HISTORIC AND DESIGN REVIEW COMMISSION

HDRC CASE NO: 2018-311
ADDRESS: 427 ADAMS ST
LEGAL DESCRIPTION: NCB 2880 BLK 5 LOT 7&8
ZONING: RM-4, H
CITY COUNCIL DIST.: 1
DISTRICT: King William Historic District
APPLICANT: Richard and Elaine Lutton
OWNER: Richard and Elaine Lutton
TYPE OF WORK: Front yard fence; wrought iron
APPLICATION RECEIVED: June 6, 2018
60-DAY REVIEW: August 5, 2018
REQUEST:

The applicant is requesting a Certificate of Appropriateness for approval to install 4' tall wrought iron fence in the front yard and along the driveway.

427 Adams Street

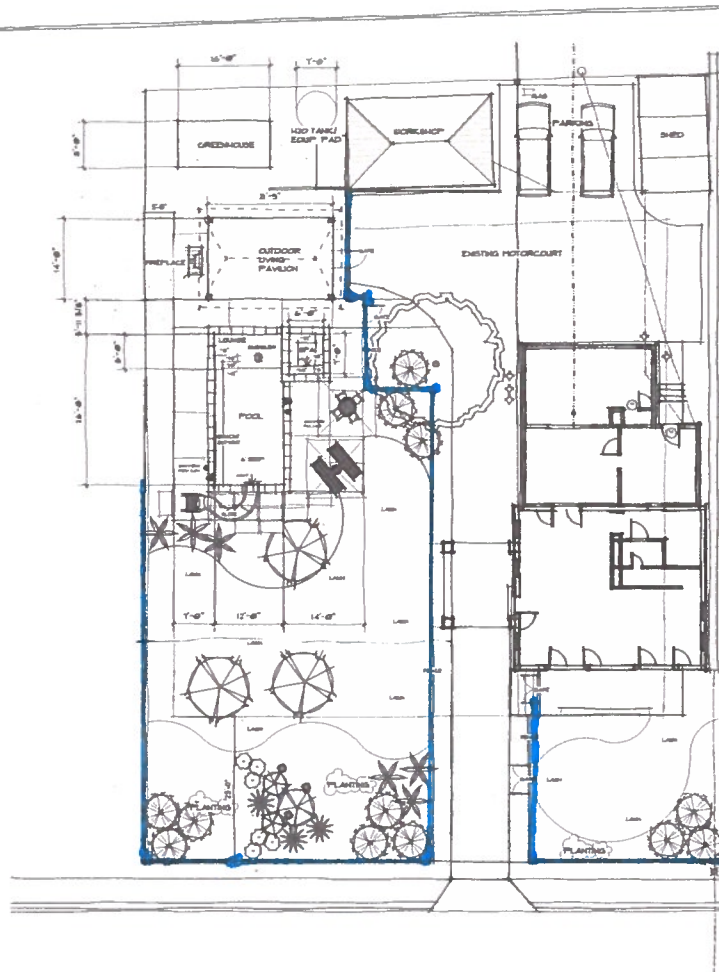
- b. FENCE LOCATION – The applicant is requesting to install a fence spanning across the front yard and turning at the driveway to meet behind the front façade plane of the historic structure, rather than spanning a gate across the front yard. According to the Guidelines for Site Elements 2.B.ii, new front yard fences should not be introduced within historic districts that did not historically. Staff finds that fences are found on Adams and within the King William Historic District. Staff finds the proposed location and configuration of the new fence appropriate.

- c. FENCE DESIGN – The applicant is requesting to install front yard fencing that features wrought iron fencing to feature a height no taller than 4ft in height. According to the Guidelines for Site Elements 2.B.i., the design of the fence should respond to the design and materials of the primary historic structure or structures of a similar style in the neighborhood in relation to scale, transparency, and character. The neighboring property at 417 Adams features a height of approximately 39 inches. Staff finds that the proposed height of the fence at 427 Adams should not exceed the height of its neighboring property at 417 Adams.

Staff recommends approval of the fence with the stipulation that no portion of the fence exceeds the height of its neighboring property at 417 Adams (approximately 39 inches).
